Further Addendum Planning Statement

Application WSCC/019/20 - Proposed construction of landscape enhancement features using imported inert materials, together with provision of public access and amenity; comprising revised landform and details to WSCC/029/18/SP

**in respect of Land at Knepp Castle Estate,
West Grinstead, West Sussex**

August 2020

Project Title: Knepp Castle Estate, West Grinstead, Nr Horsham
The Matthews Group
Drawing Title: Masterplan (Soft Landscape Layout)
Sheet 01 of 02 (North)

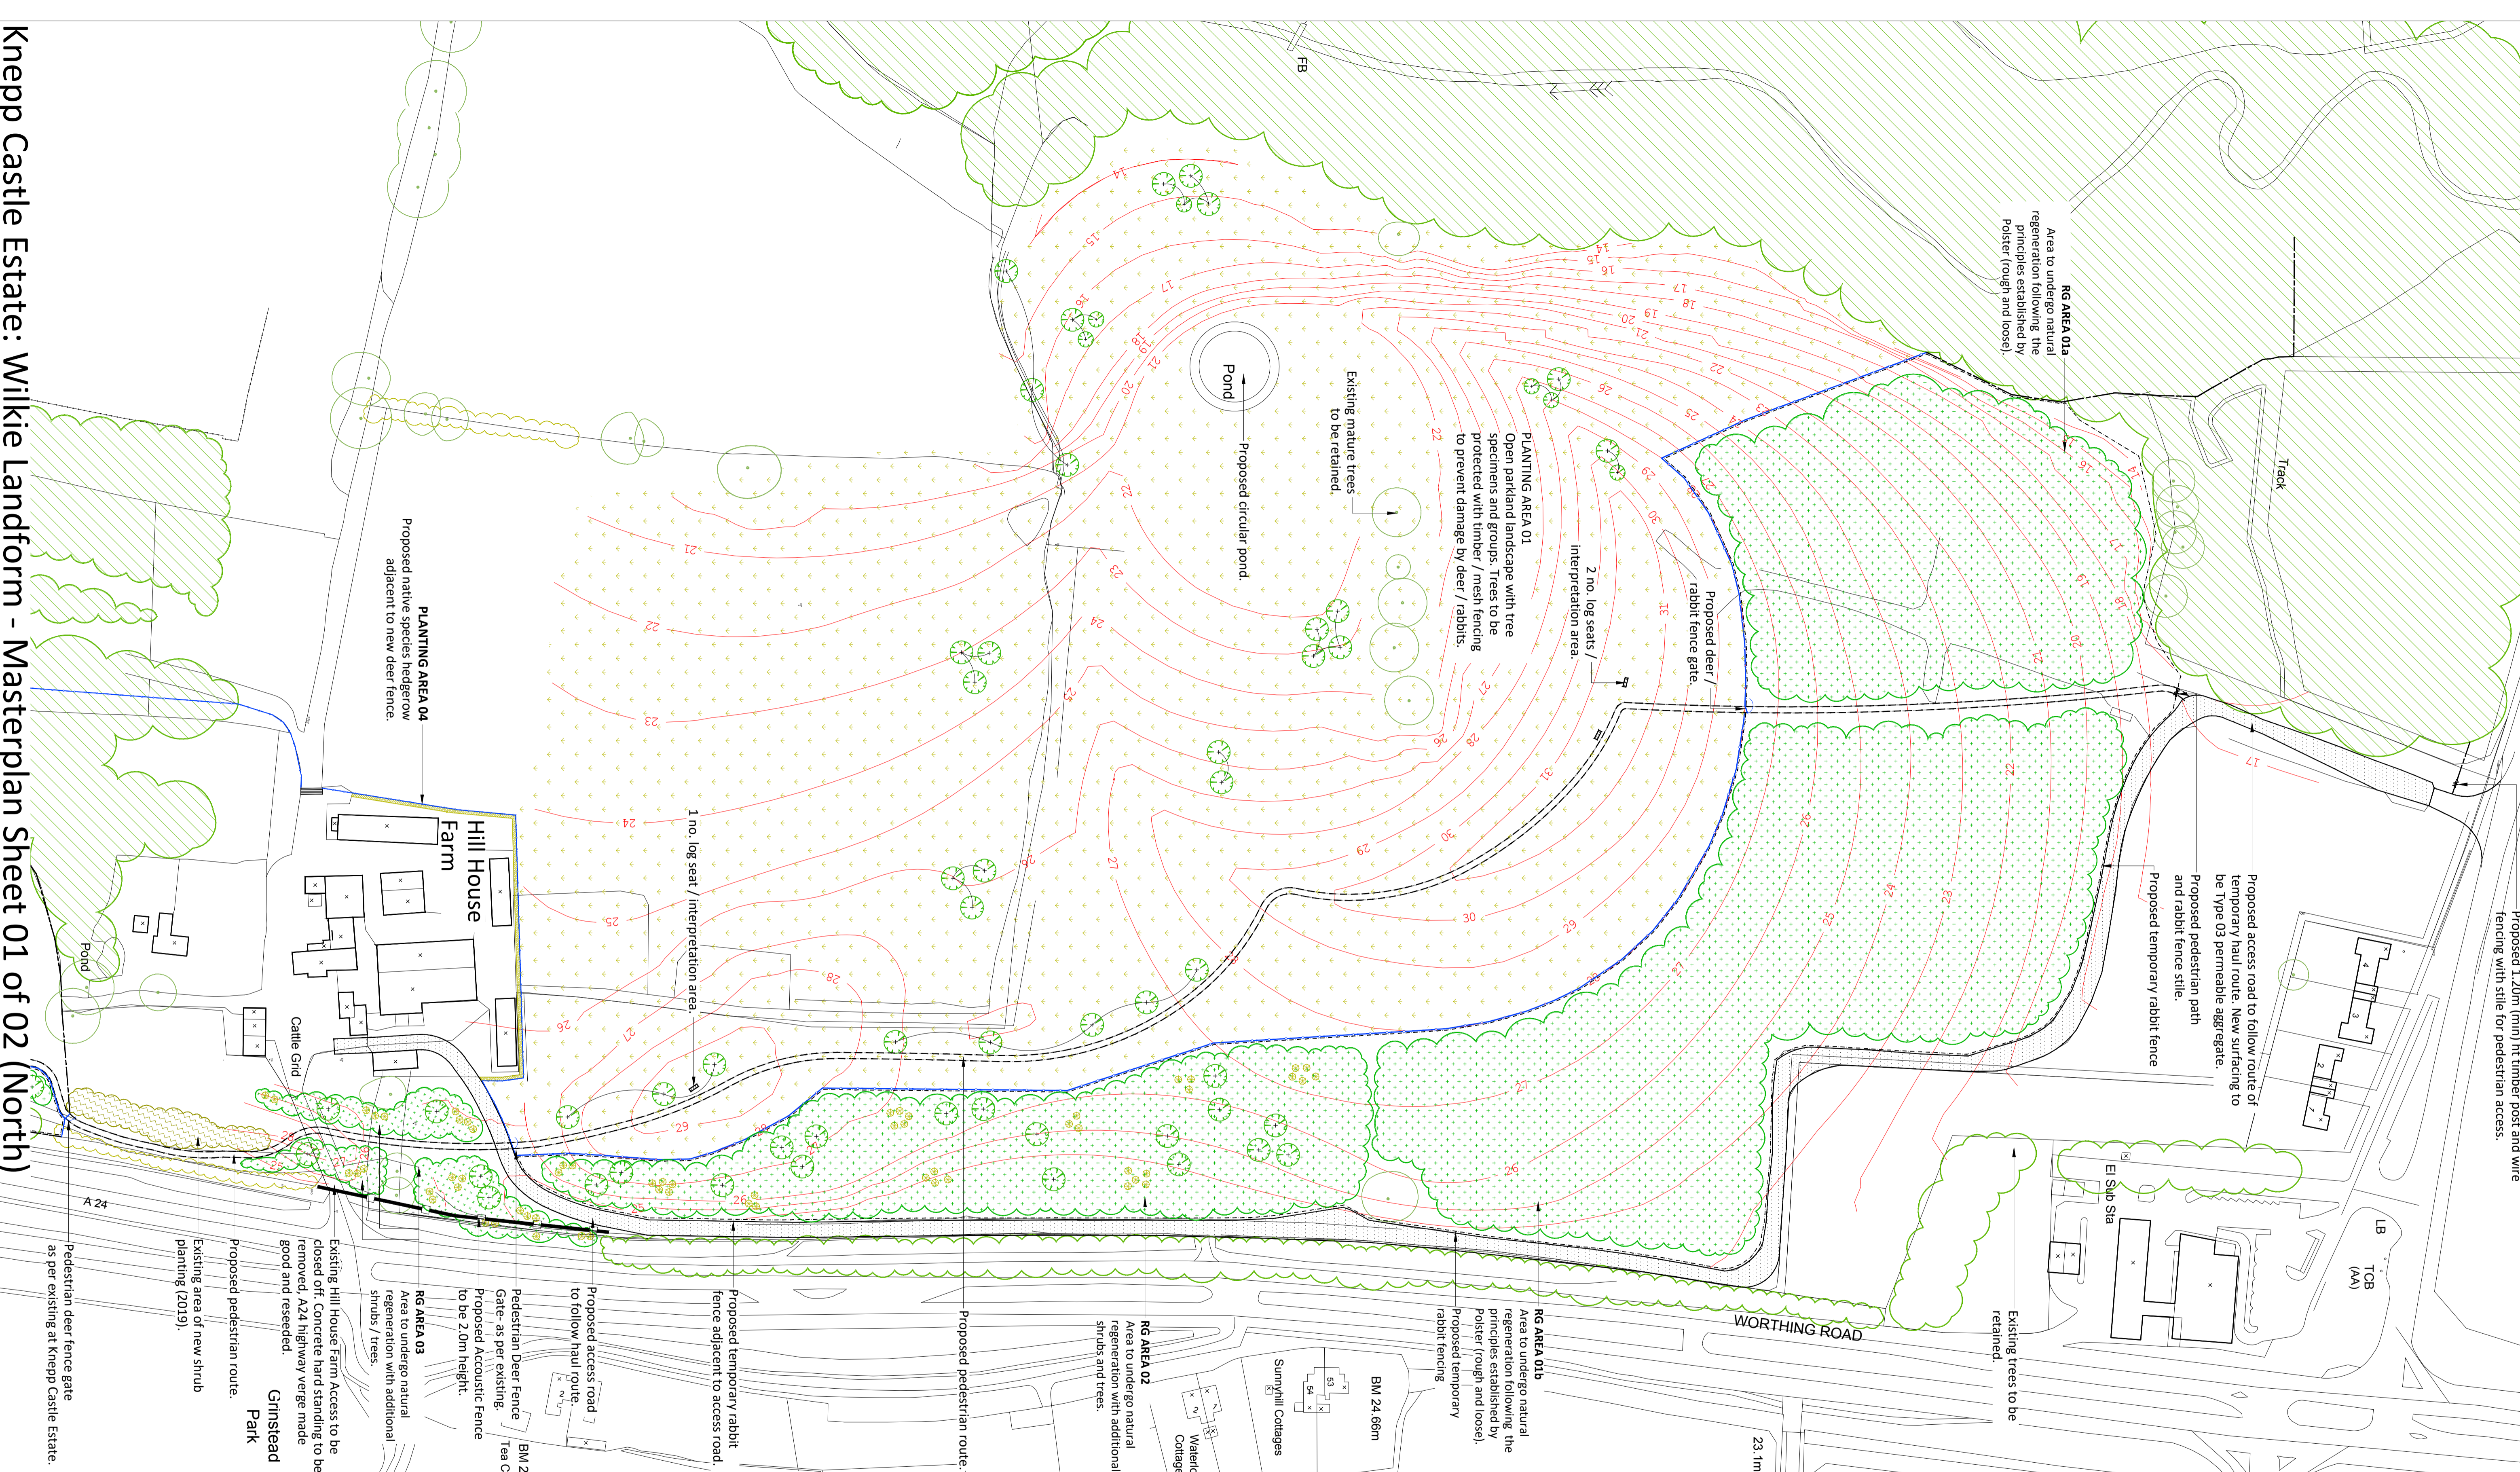
REV	DESCRIPTION	DATE	INITIALS
01	Updated with additional detail	14.07.20 AR	
02	Layout updated following comments	17.07.20 AR	
03	Layout updated for planting	26.07.20 AR

Project Title	Scale	Initials	Date
Knepp Castle Estate: Proposed Landform Enhancements	1:200@A3	AR	06-02-20
Drawing Title	Drawing Number	Revision	
Public Car Park Layout	RCO201 / 15	02

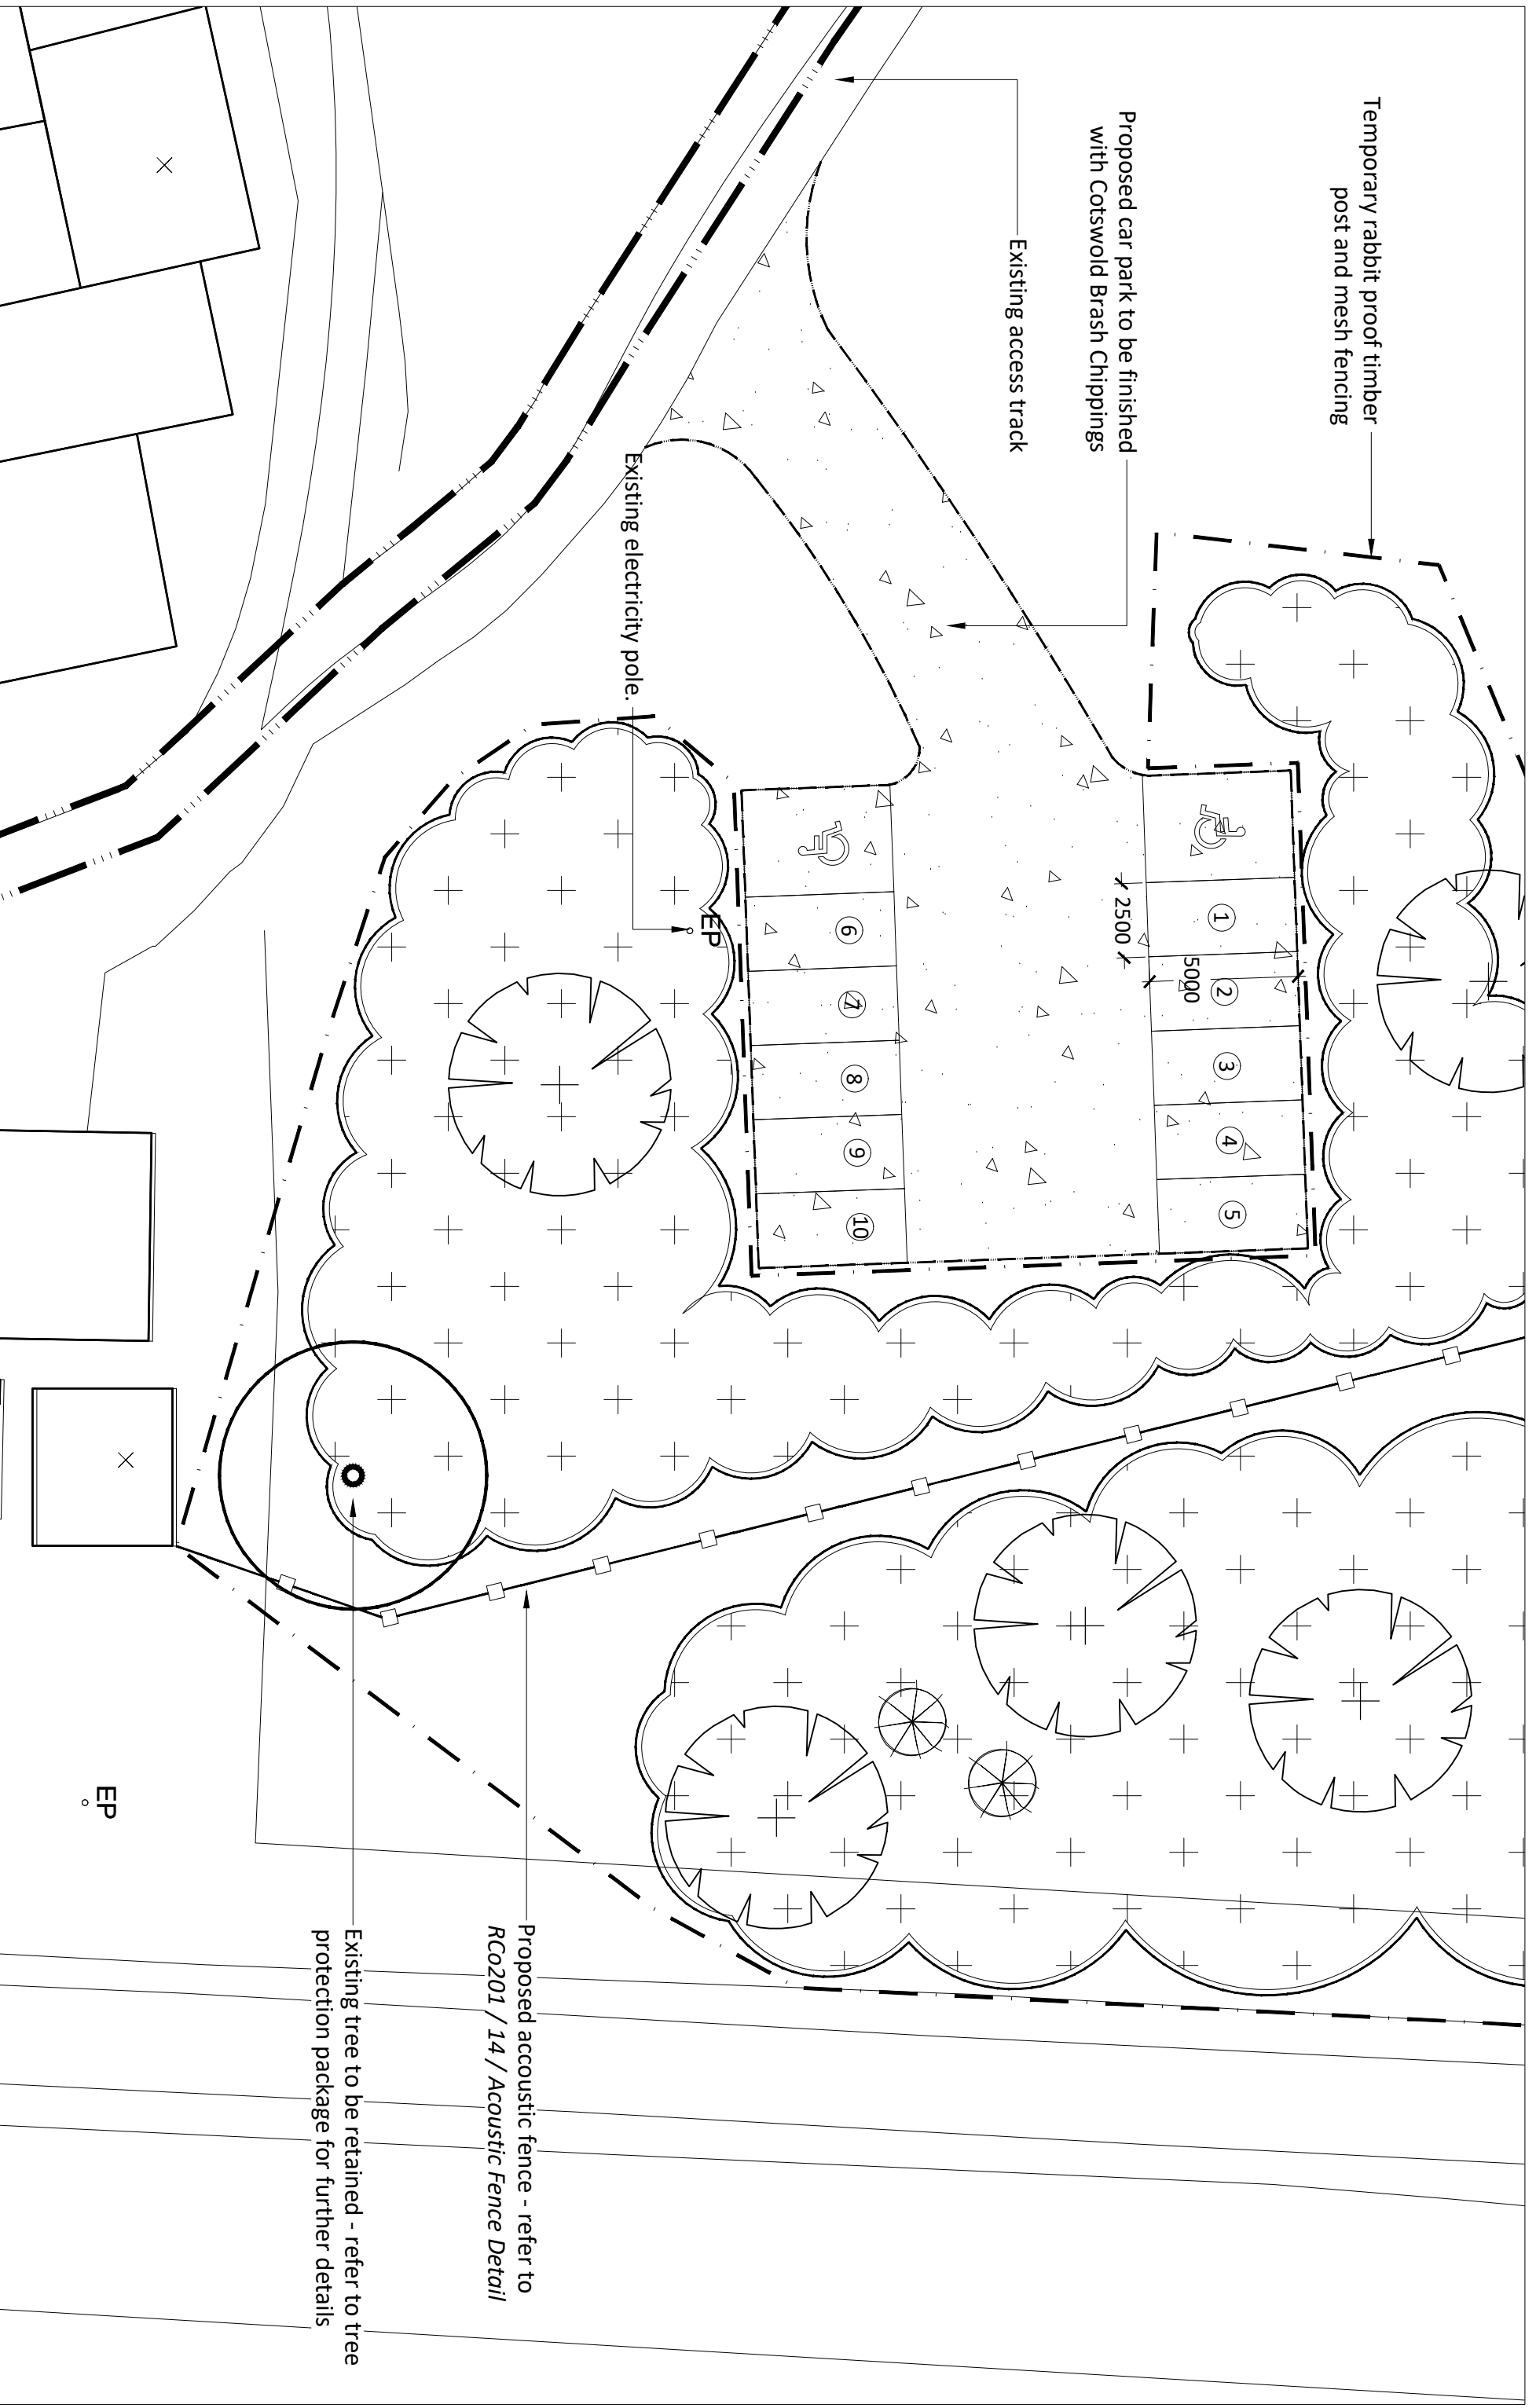
REV.	DESCRIPTION	DATE	INITIALS
01	Car park location moved north to avoid pole	14.07.20 AR	
02	Layout updated for planning	23.07.20 AR
